**Functional Servicing Report - The
Village at Fairview Greens**

**883890 Ontario Limited c/o Fergus
Development Inc
3190 Steeles Avenue East, Suite 300
Markham ON L3R 1G9**

**April 2023
300052719.0500**

**Re: Fergus Golf Course Redevelopment Project
Pre-submission Consultation Document for ECA Application
Response to MECP Comments
Project No.: 300052719.0000**

BURNSIDE			
Client			
FERGUS DEVELOPMENT INC.			
Figure Title			
THE VILLAGE AT FAIRVIEW GREENS			
PROPOSED WASTEWATER TREATMENT SYSTEM CONCEPT			
Drawn	Checked	Date	Figure No.
BF	AE	23/03/16	
Scale	Project No.		7
1:4000	300052719

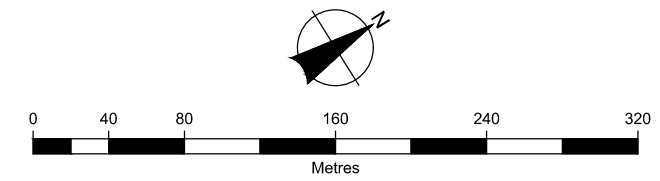
Response:

Our submitted Figure 1 provides topographic contours and the interpreted direction of groundwater flow, which is generally to the north/northeast. Shallow groundwater conditions were investigated at 16 monitoring wells that were installed by Golder. Groundwater level data were evaluated along with the topographic information to determine shallow groundwater flow direction. As shown on Figure 5 of the Golder Hydrogeological Investigation, shallow groundwater flow is controlled by topography and is generally to the north/northeast on the golf course portion of the property. There is a groundwater divide in the southwest area of the property; however, this area of the site contains only a small portion of the playable golf course area (i.e., tees and greens associated with two holes, and a small portion of fairway amounting to approximately 7% of the total area). Therefore, 93% of the area over which effluent will be irrigated is to the northeast side of the groundwater divide, where the direction of groundwater flow is toward the north/northeast. We have therefore focused our assessment of potential impacts on this portion of the site.

Figure Title
THE VILLAGE AT FAIRVIEW GREENS
NORTH IRRIGATION PONDS

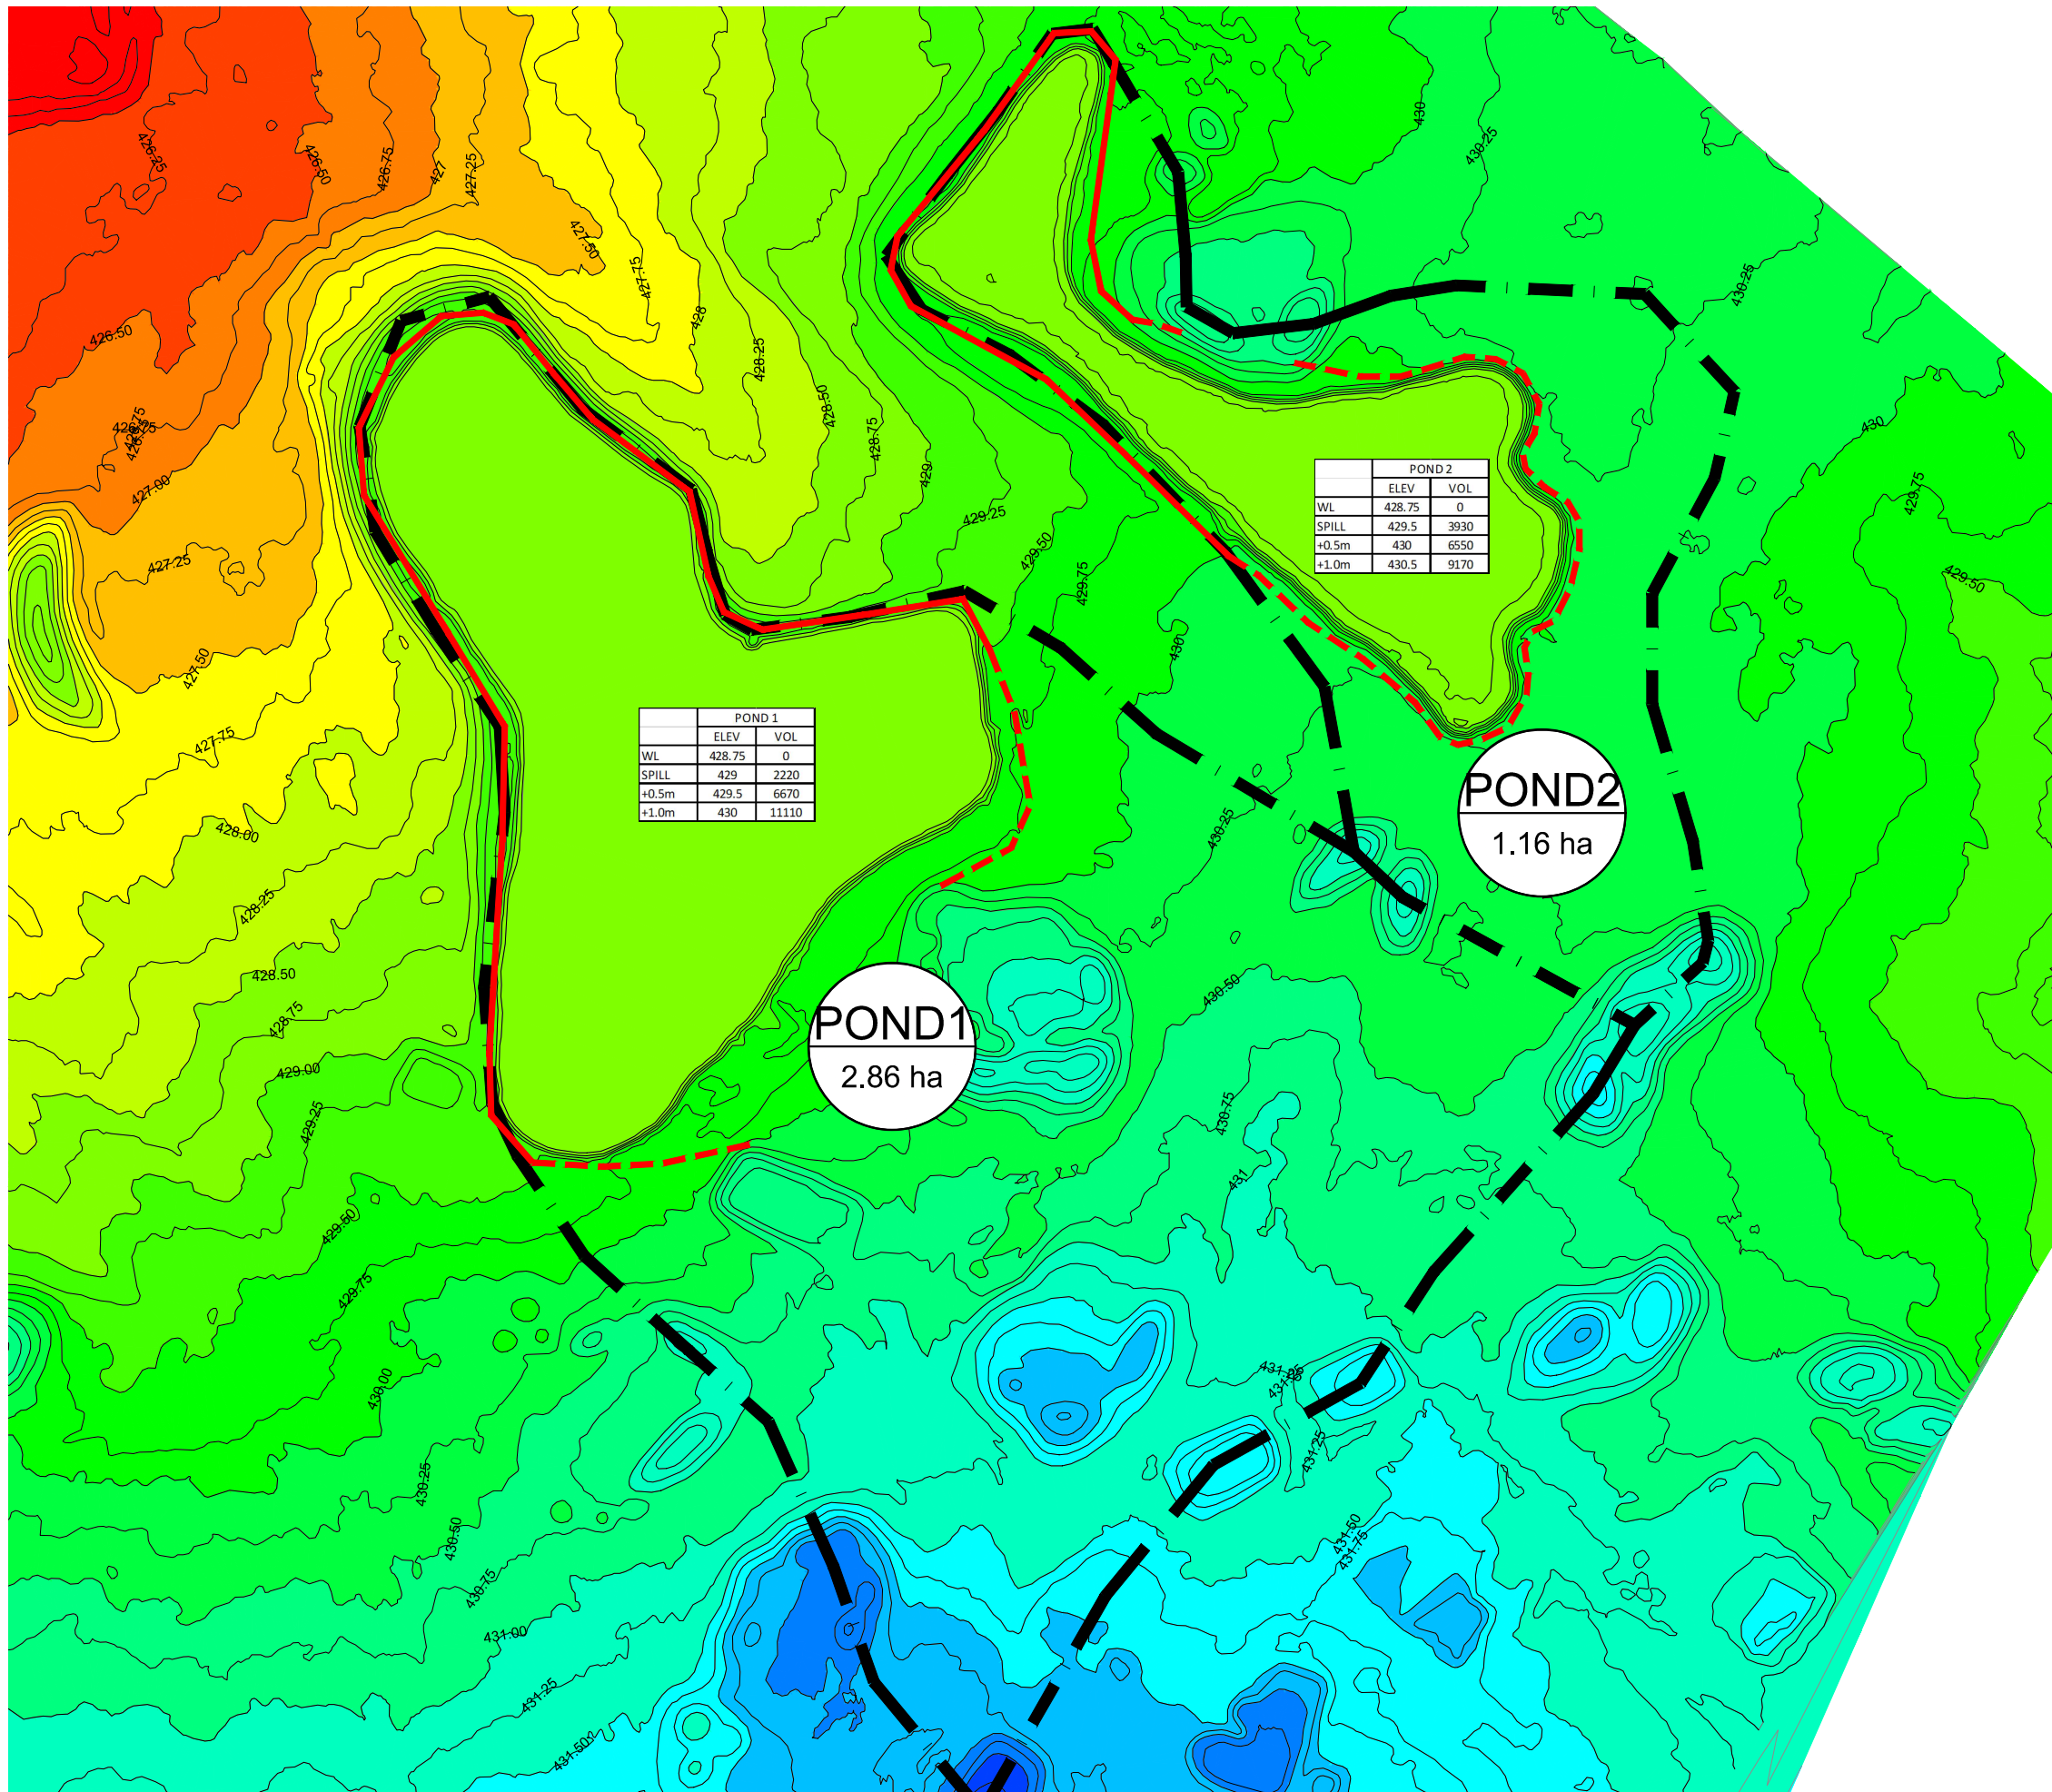
2. *A monitoring and contingency plan should be prepared in case of severe precipitation that would require the prevention from the pond overtopping (i.e. pumping the pond and disposing of the waste effluent)*

- a) The 100-year storm event was analyzed to ensure that no single rainfall event would overtop the edges of the pond. Utilizing very conservative values, the total expected volume of flow from the 100-year storm event is 1,881 m³. A pond level monitoring plan (noted below) will ensure this capacity is available for these uncommon storm events.
- b) In addition, we have prepared an annual water balance analysis for these two pond areas. As discussed, a summary below of the water balance, and the Water Balance calculation (refer to Table D-1 attached):
